CITY OF ALBUQUERQUE

March 22, 2023

RE: **Lot 12 Block 2 Unit 22 SAD 228
6304 Petirrojo NW
Grading and Drainage Plan
Engineers Stamp Date: 3/15/2023 (D10D003F12)**

ENGINEER'S SEAL	LOT 12 BLK 10 UNIT 22 VC 6304 PETIRROJO	DRAWN BY DEM
	GRADING AND DRAINAGE PLAN	DATE 3-15-23
		6304 Petirrojo.DWG
		SHEET # C1
3/15/23		JOB #
DAVID SOULE P.E. #14522

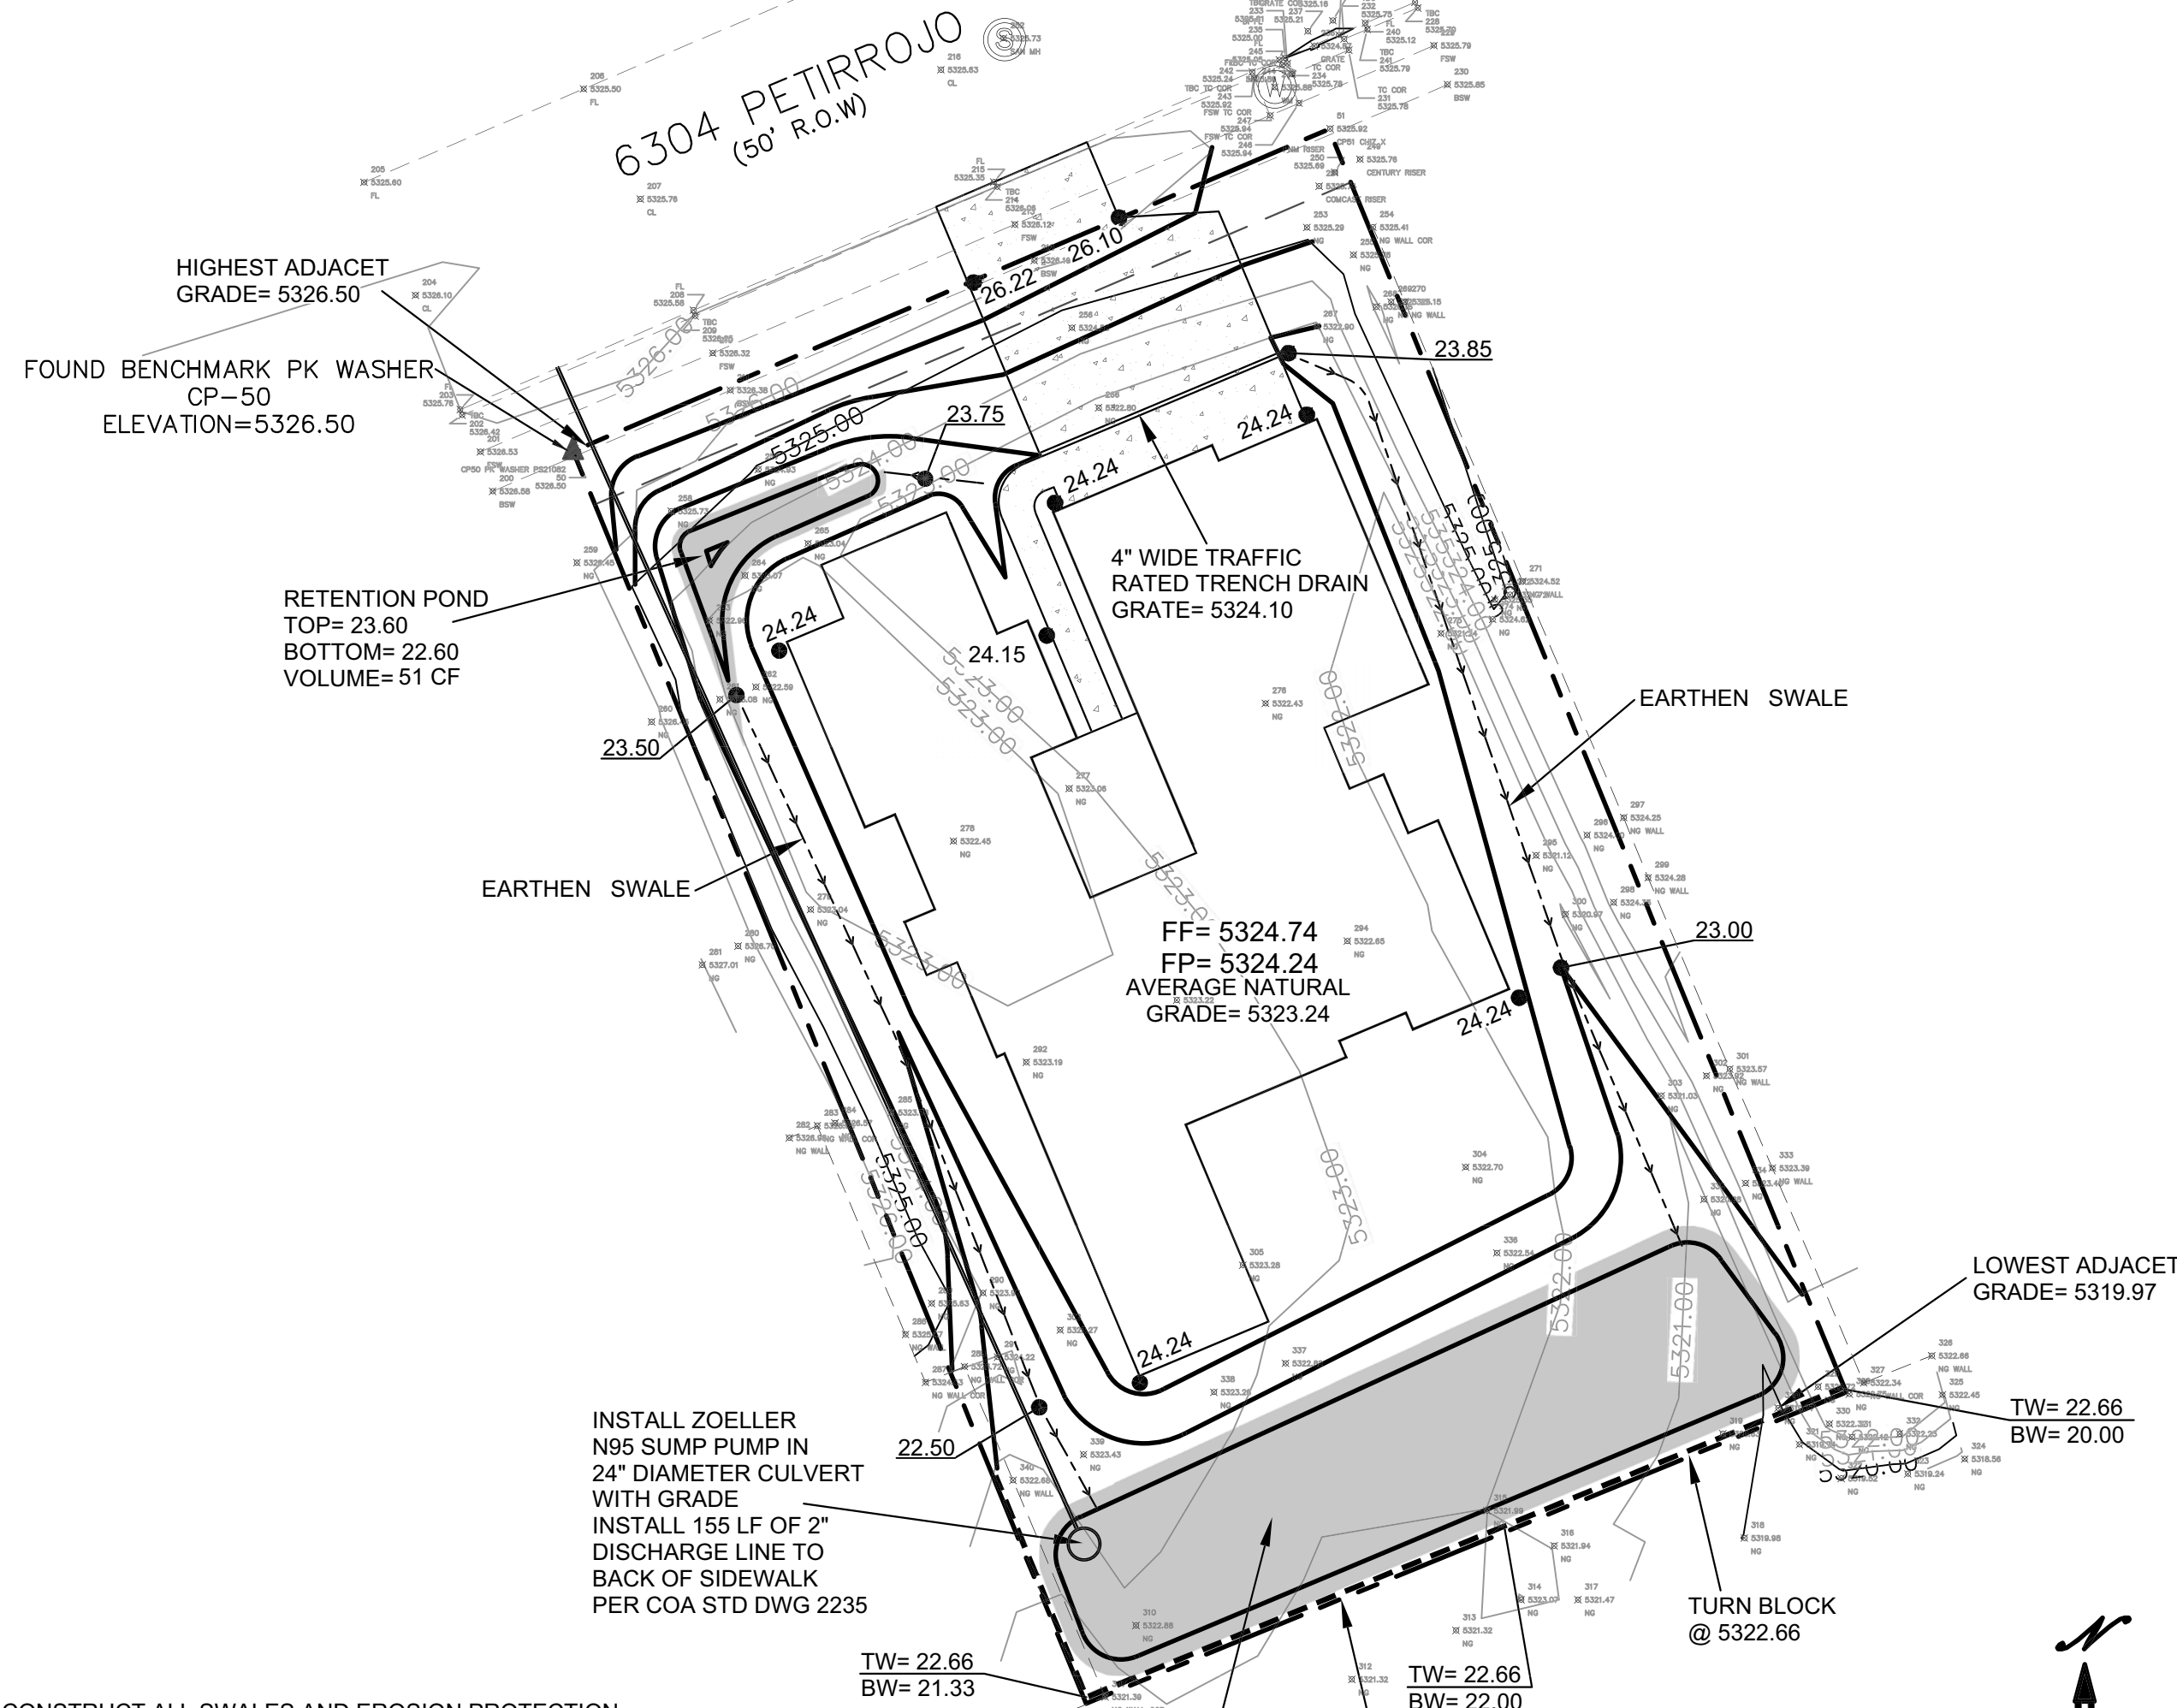
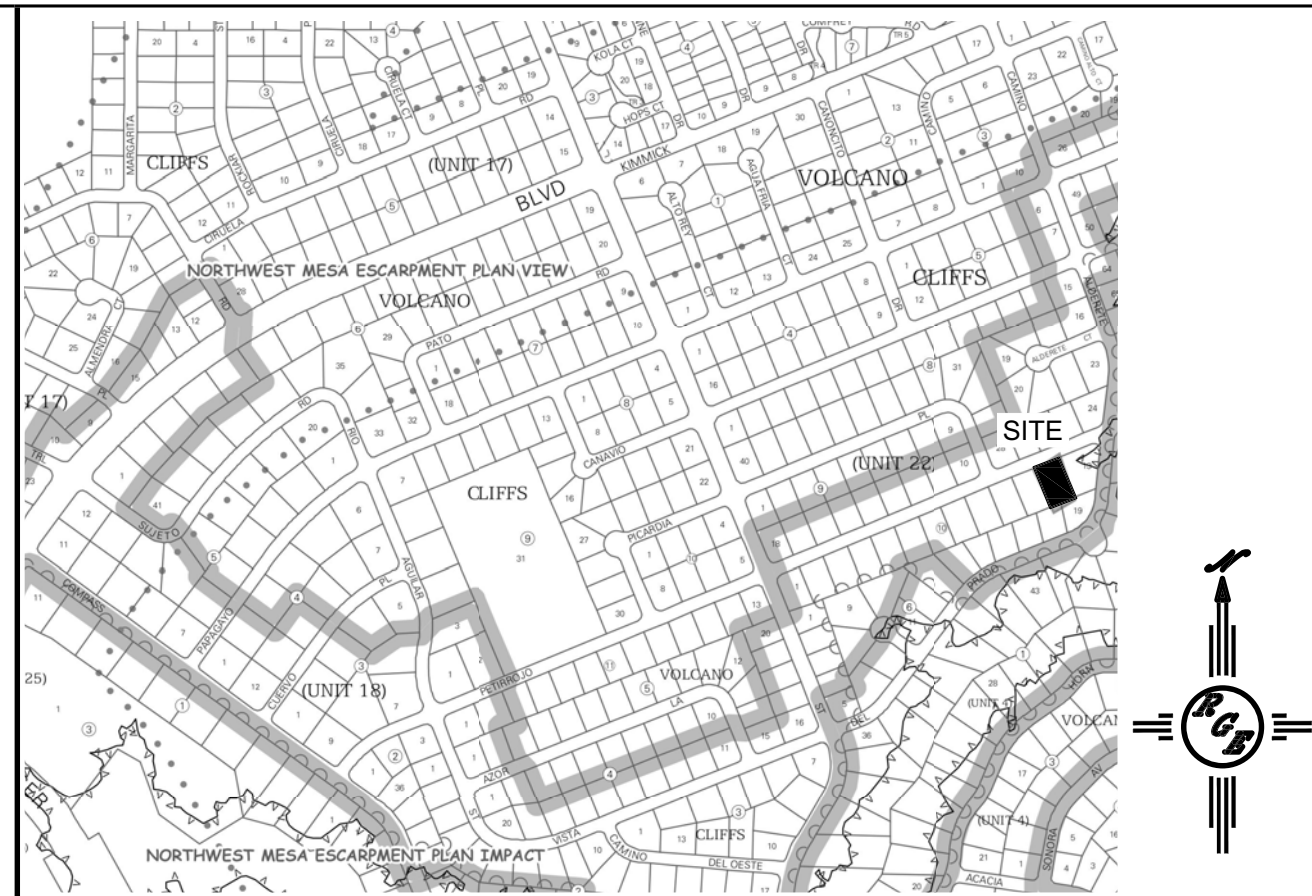
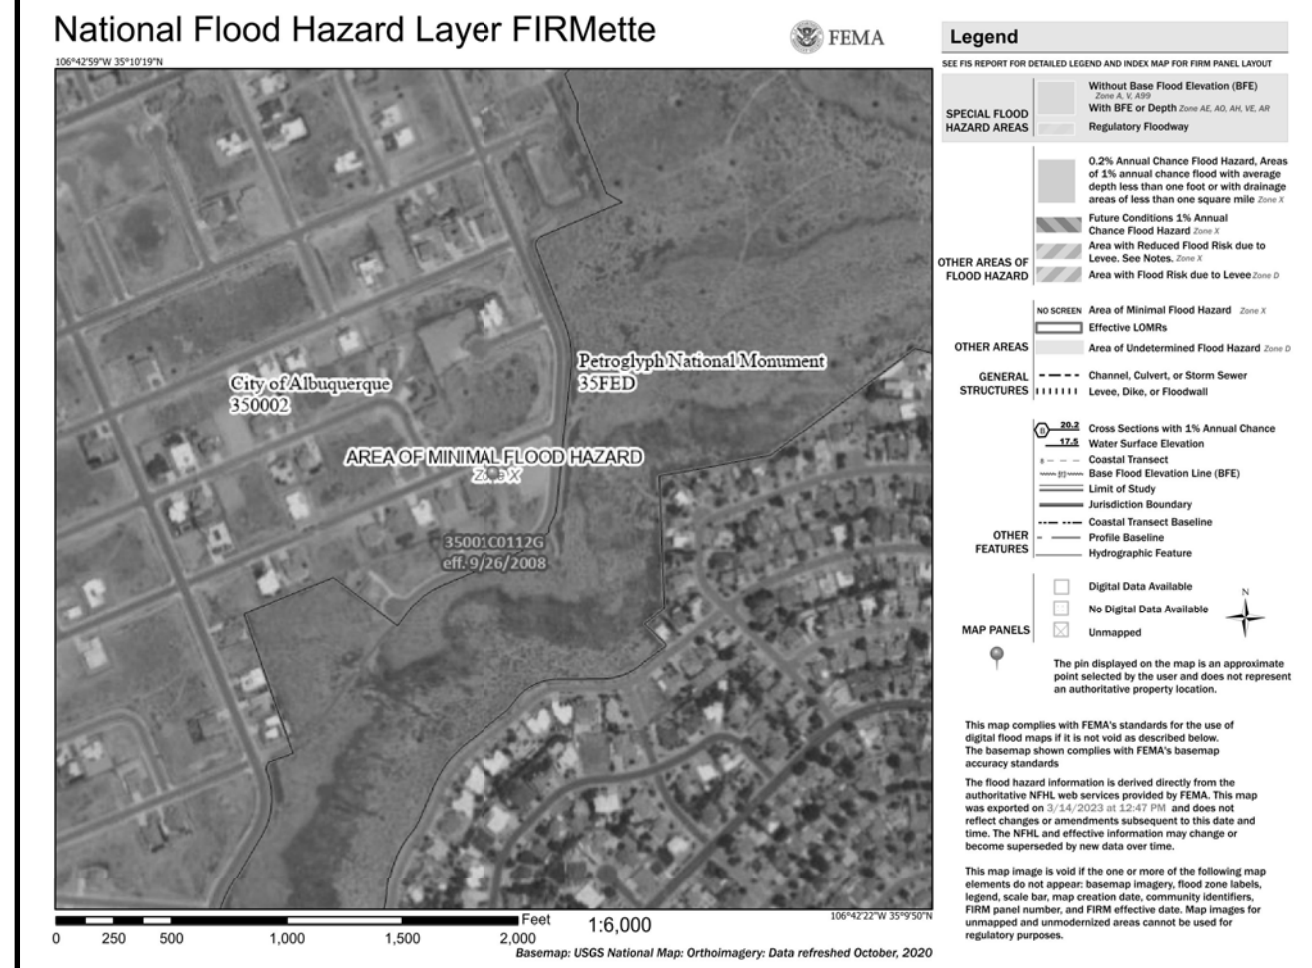
Based upon the information provided in your submittal received 3/17/2023, this plan is approved for Grading Permit.

Prior to Building permit approval a Pad Certification will be required, provided by the Engineer or a registered Land Surveyor.

Advise the owner contractor not to use dirt as a ramp to climb the curb, use lumber or crusher fines for this purpose.

Reiterate to the Owner/Contractor that a separate permit for a garden/retaining wall must be obtained with the approved G&D plan and Pad Certification. Also, if a swimming pool is to be placed the grading and drainage plan will change and will need to be resubmitted.

Prior to Certificate of Occupancy release, Engineer Certification per the DPM checklist is required.
